REMARKS

Docket No. 1522-K-CONT

Enclosure - Replacement drawings sheet (Figs. 17 & 18)

FIG-18

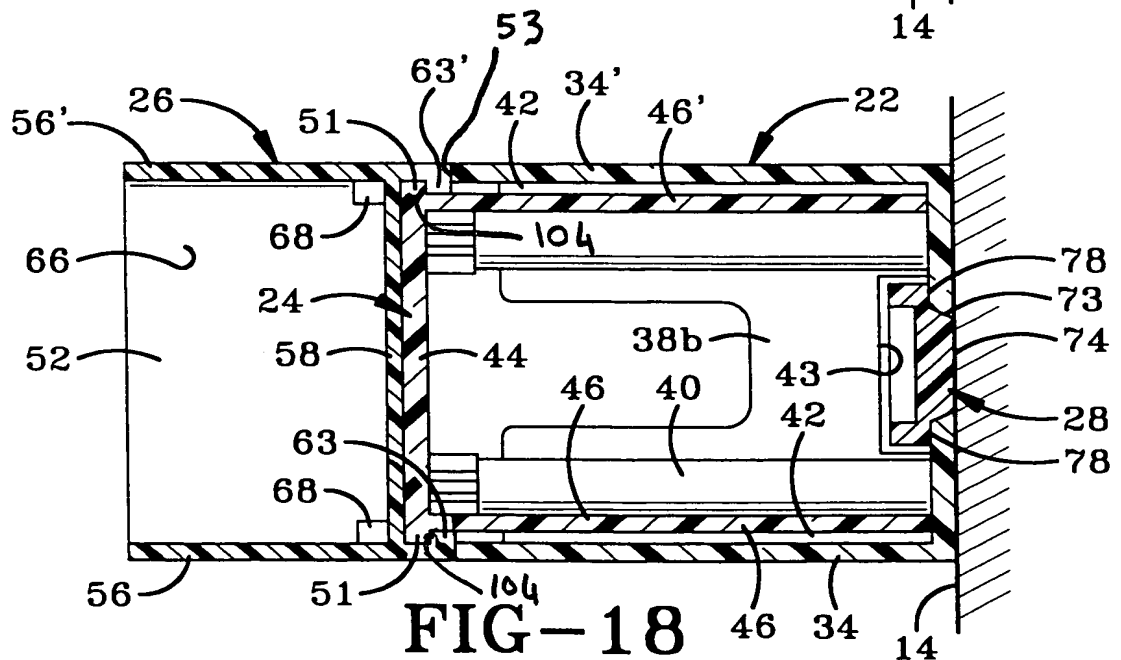
The Examiner objected to the drawings under 37 C.F.R. 1.83(a) in that the drawings need to show every feature of the invention specified in the claims.

Specifically, the Examiner requires that the “front wall” (line 3 of claim 1); “first connector mechanism” (line 6 of claim 1) and “second connector mechanism” (line 9 of claim 1) must be shown or the feature(s) canceled from the claims. **In response,** Applicant respectfully submits that these features are already shown in the drawings.

The **“first connector mechanism”** is shown in Fig. 18, the first connector mechanism being an interlocking ridge/boss and a groove. The first connector mechanism thus comprises the rim 51 on the bracket interlockingly received within the second groove formed between the rear wall 58 of the rail connector and the ridge 63 of the rail connector. Alternatively or additionally, the ridge 63 is interlockingly received within a first groove formed between the end of the side wall 34 or 34' and rim 51.

Applicant attaches hereto a replacement drawing sheet including Figs. 17 & 18. In the amended Fig. 18 the second groove has been numbered “104” in conformity with page 8, lines 3-6 of the specification and with Fig. 9 which shows the details of the rail connector prior to attachment to the bracket. Furthermore, the amended Fig. 18 shows the first groove which has now been numbered “53” in accordance with Fig. 3 and page 6, lines 8-12 of the specification. The rim 51 interlocks with the second groove 104, and

the ridge 63 interlocks with the first groove 53 and thereby join the rail connector and bracket together. The first and second grooves 53, 104 have been numbered for ease of use of Fig. 18 when reading the specification. No new matter has been added by way of this amendment.

Inasmuch as all of the referenced features are shown in the drawings, Applicant respectfully requests that the replacement sheet including Fig. 18 be accepted by the Examiner and respectfully requests that the objection to the drawings under 37 C.F.R. 1.83(a) be withdrawn.
